## Draft Regulation on hydrogen and fuel cell vehicles

### Submitted by the experts from the European Commission and the International Organization of Motor Vehicle Manufacturers \*

## Uniform provisions concerning the approval of motor vehicles and their components with regard to the safety-related performance of hydrogen-fuelled vehicles

Figure 1  
Typical compressed hydrogen storage system

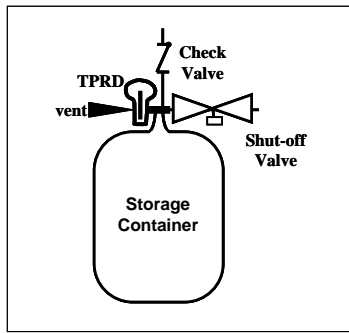
The primary closure devices that isolate the high pressure hydrogen storage system, namely TPRD, check valve and shut-off valve, as described in Figure 1, shall ~~comply with one of the following requirements:~~

Retesting of the storage system is not required if alternative closure devices are provided having comparable function, fittings, materials, strength and dimensions, and satisfy ~~one of~~ the condition[s] above. However, a change in TPRD hardware, its position of installation or venting lines shall require a new fire test in accordance with paragraph 5.4.

Figure 3  
Verification test for expected on-road performance (pneumatic/hydraulic)

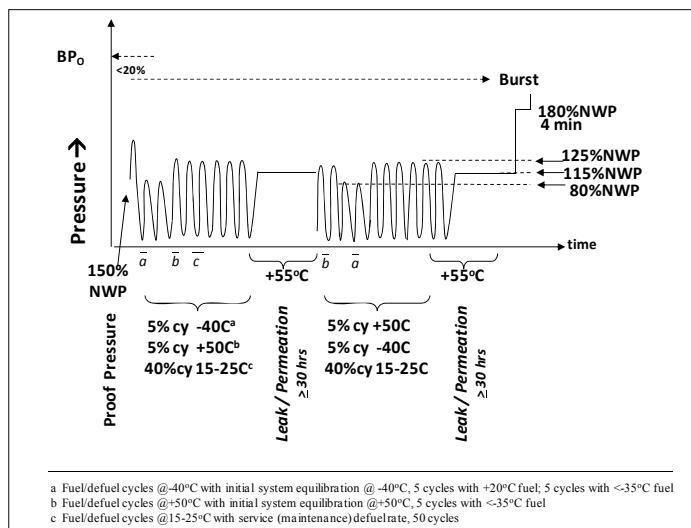
The storage container undergoes a hydraulic burst to verify that the burst pressure is ~~within 20~~ **at least 80** per cent of the baseline **initial** burst pressure (**BP<sub>0</sub>**) determined in paragraph 5.1.1. (Annex 3, paragraph 2.1. test procedure).
